TO: T10 Membership
FROM: Paul A. Suhler, Quantum Corporation
DATE: 18 February 2009
SUBJECT: T10/08-409r9, ADT-2: Internet ADT (iADT)

Changes to ADT-2 rev. 5

Figure 34 — Example Media Changer application of ADT

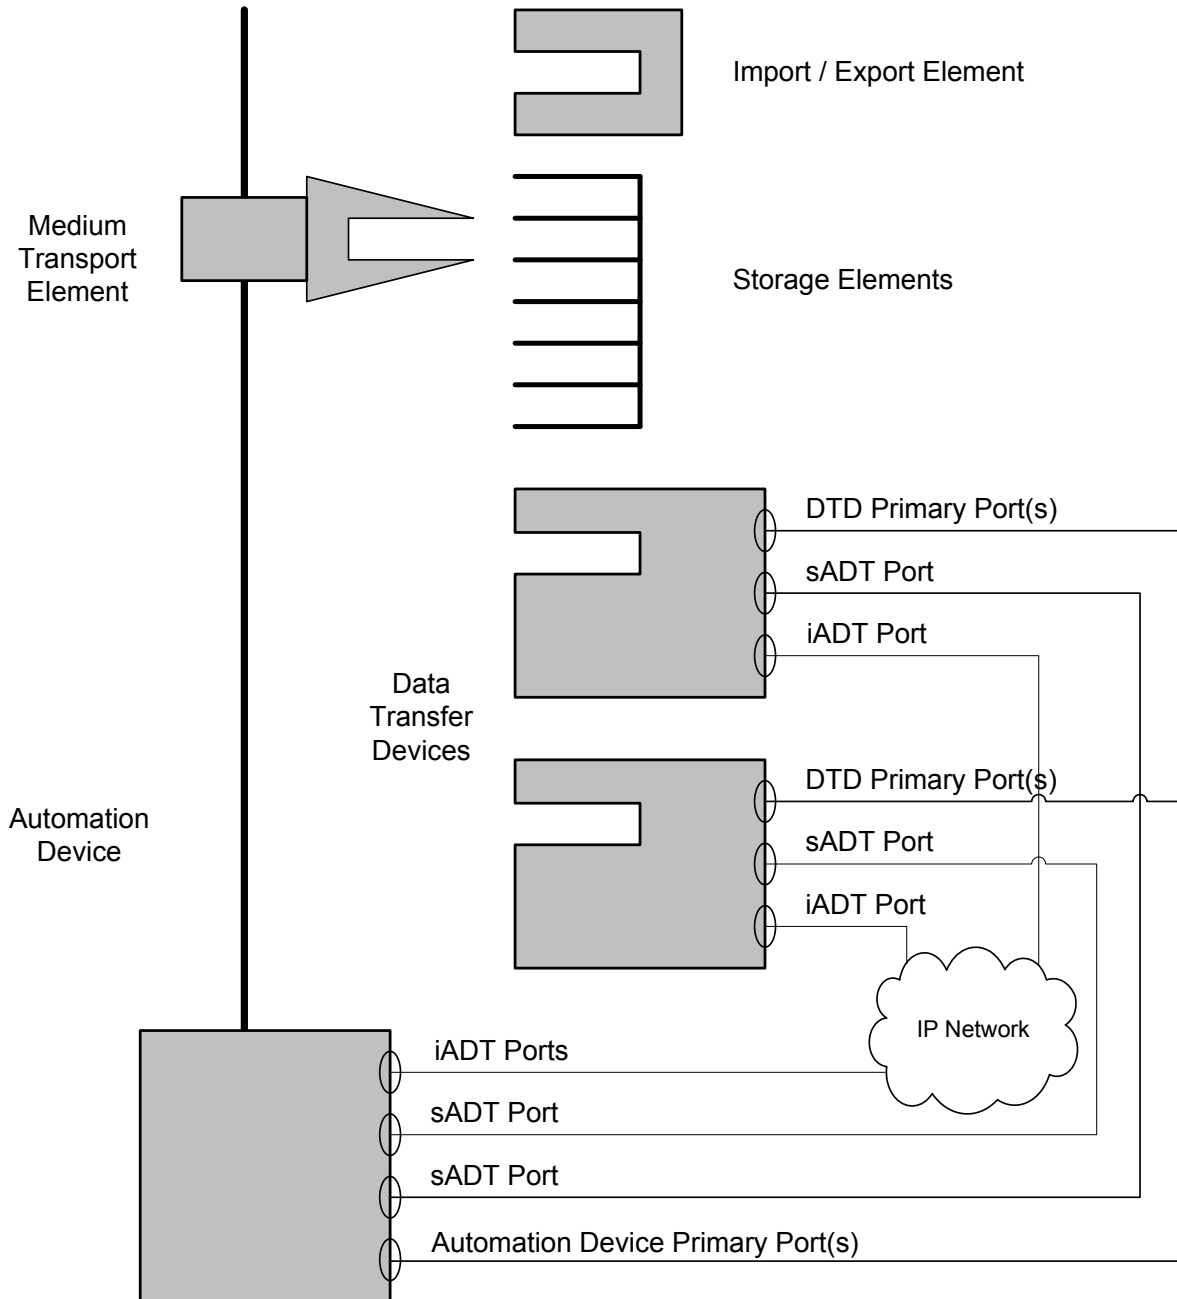
Figure 3 4 shows **an example of an ADT interface** examples of serial ADT (sADT) and internet ADT (iADT) interfaces (see 4.1.2) within a media changer containing two DT devices. Other common components of a media changer are also shown for reference. The components of an automation device are medium transport elements, data transfer (DT) devices, storage elements, and import/export elements (see SMC-3). The automation device may communicate with the DT devices through ADT ports, as defined in this standard. DT devices and automation devices communicate with initiator ports other than those in the automation device using primary ports.

Replace and renumber Figure 3:

4.3.2.5.2 Transition P3:Logged-out to P0:Initial

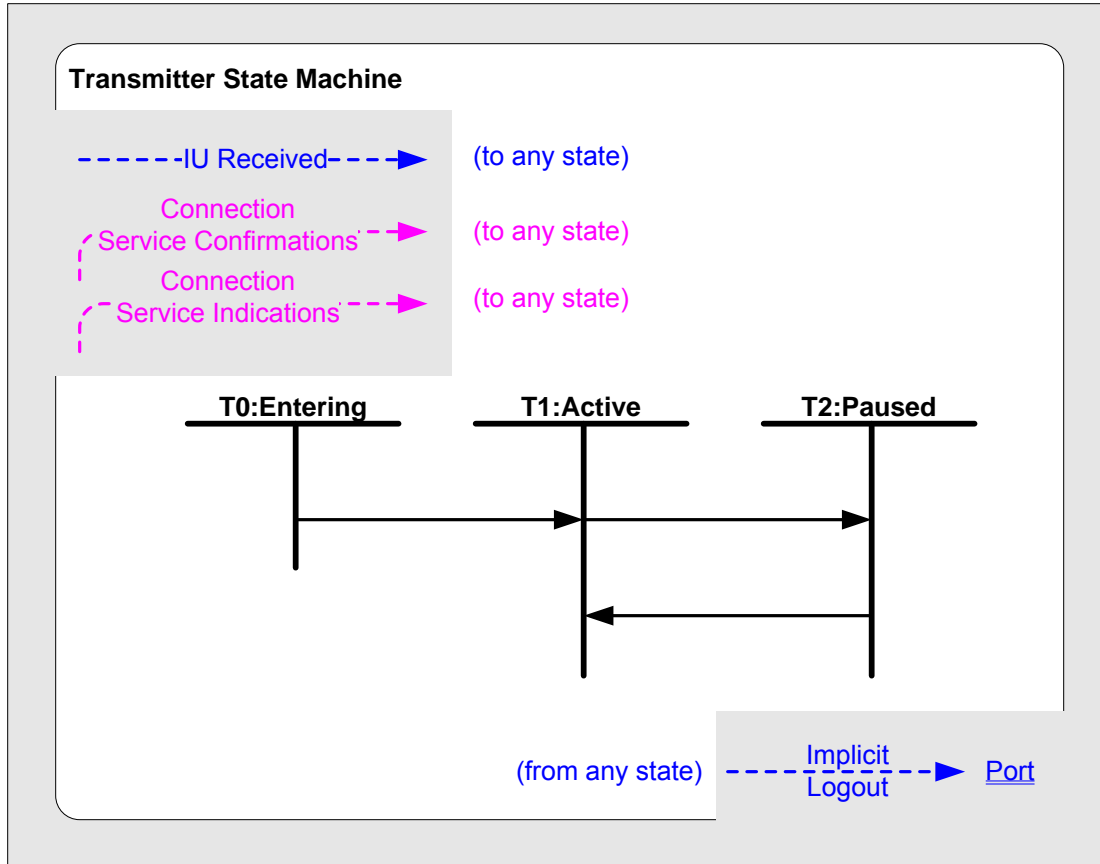
A port shall transition to P0:Initial after the logout duration time ~~specified in the Port Logout IU (see 6.5.5)~~ has expired.
